Objections to

RMM/2022/0678 Dwellings (205) Fivefield Road

RMM/2022/0678 should be rejected because

ref: layout map 2 of 2 Fivefield Rd, 1 to 500, 1656929

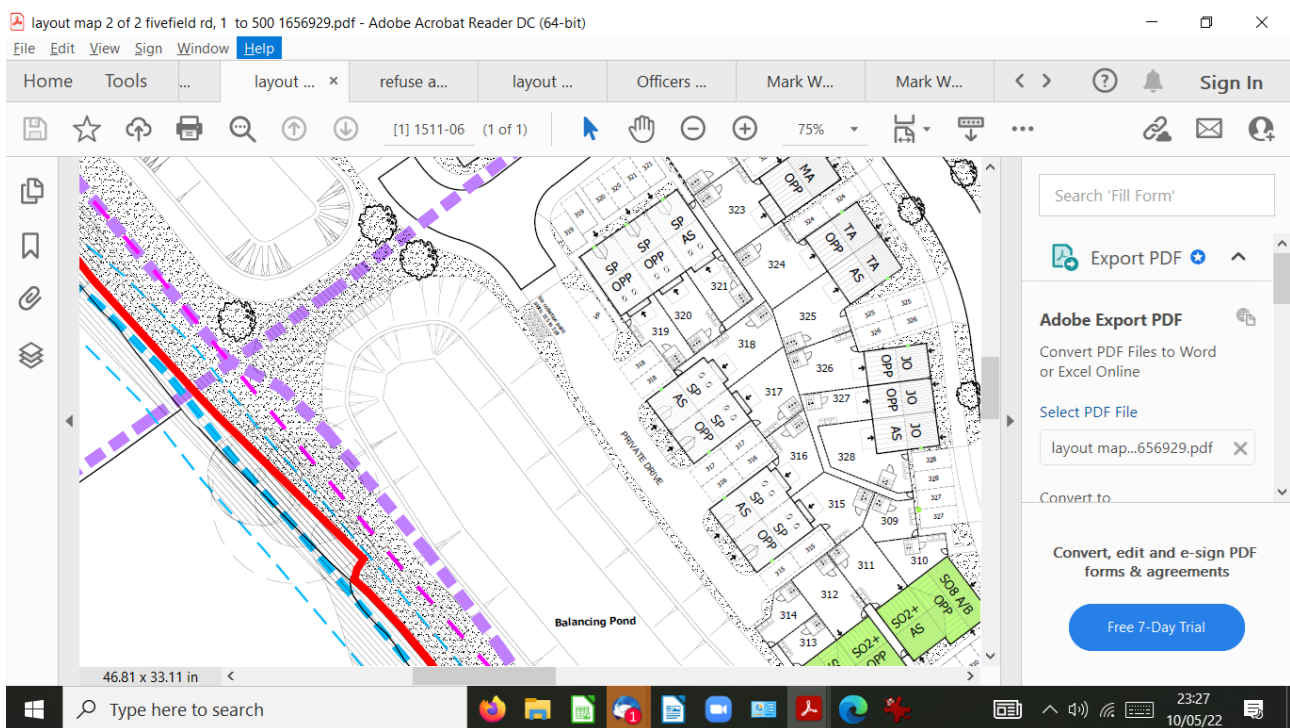
Focus : plot 273. the access private drive is 39m long (around the bend) and there is no turning place

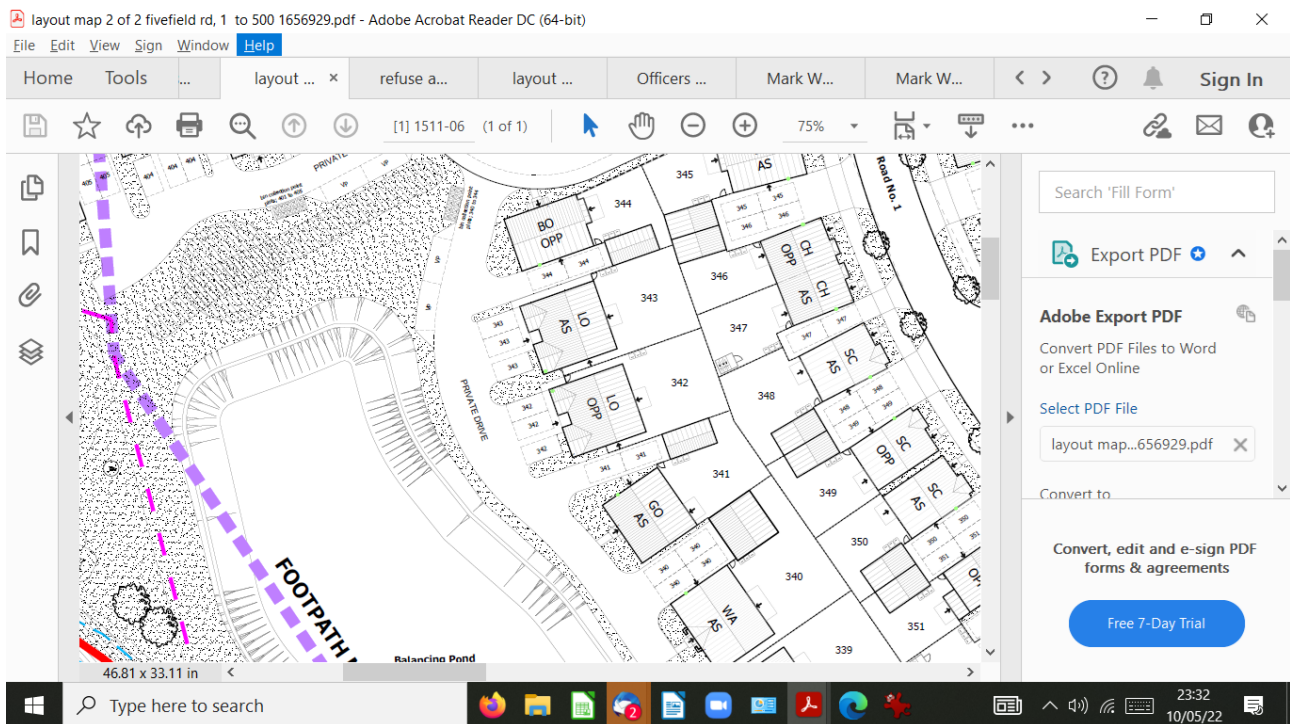
Focus house 314. private drive is 51m long and has no turning point of the required width [16.8m] the max turning space is 5.6m if cars are in the bays.

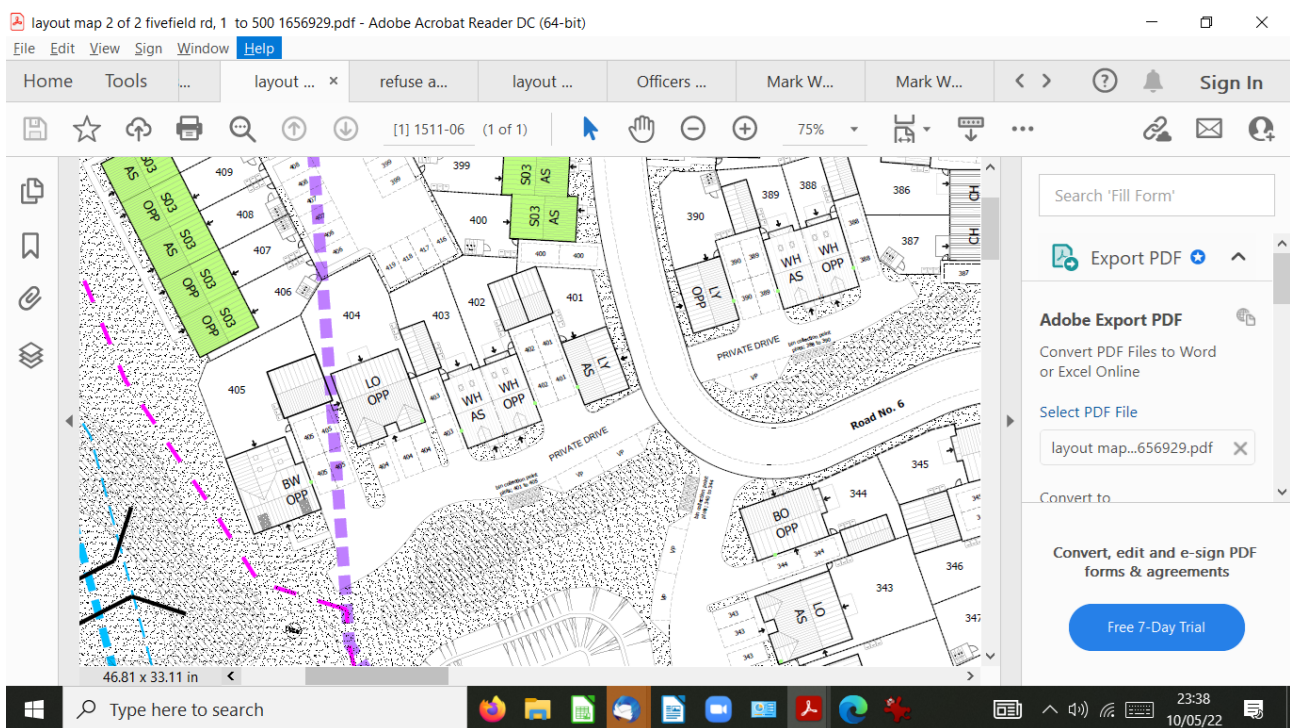
Focus: plot 344 and nearby. The private drive is 108 m long. The max turning space, if the car bays are occupied is 8.4 m (16.8 is min the regs)

Focus : plot 405 and nearby. The private drive is 47m long and has no turning space – the widest turning point is 5.5m

refuse and fire tender tracking 2 of 2, Fivefield Rd 1656912

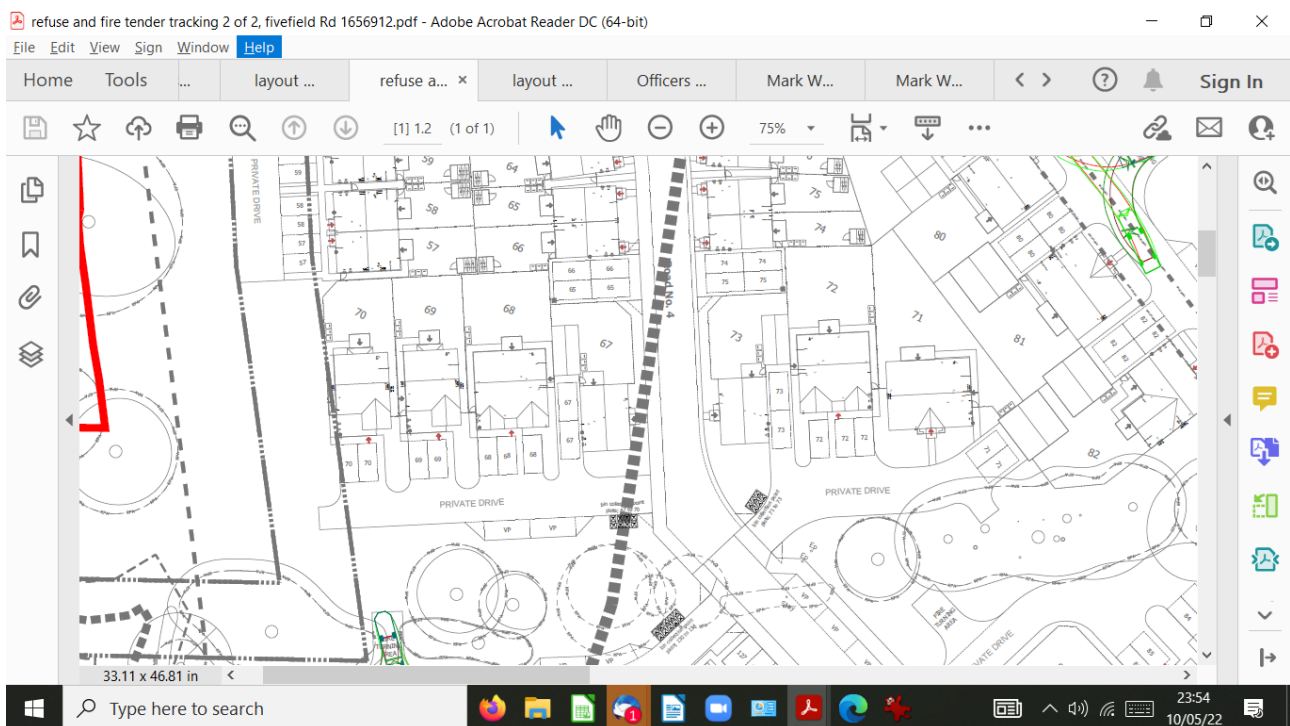
Focus: plot 61 and nearby. The private drive is 38 m long and has no turning point.

Plots 67-70. private drive is 42 m long and has no turning point. The best turning width is 5.5m if the car bays are occupied.
